Access Compliance Report Public Rights-of-Way (Curb Ramps)

Main Street: WINTHROPE_ST Cross Street: OAK_RIDGE_DR Location: SW

ADA ID: RPAT211007102501 Ramp Type: Type 1 - Perpendicular Diagonal Initial Pass/Fail: Fail Overall Compliance: No Severity Score: 2

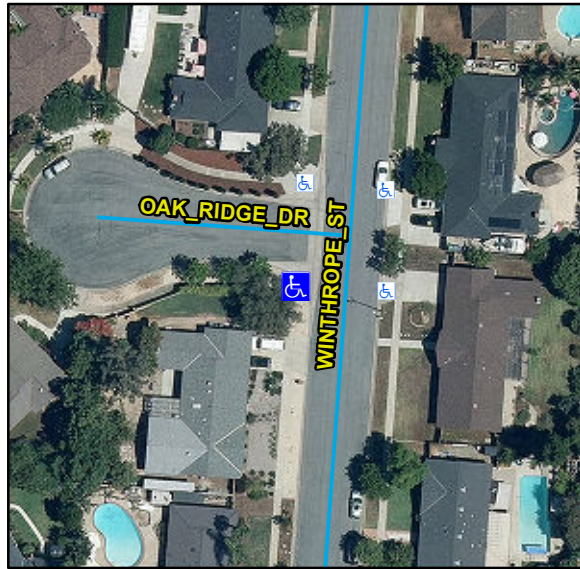
R304.2.2, R304.5.3, STD 1115

Remove & Replace Curb Ramp With Two New Directional Ramps or Equivalent.
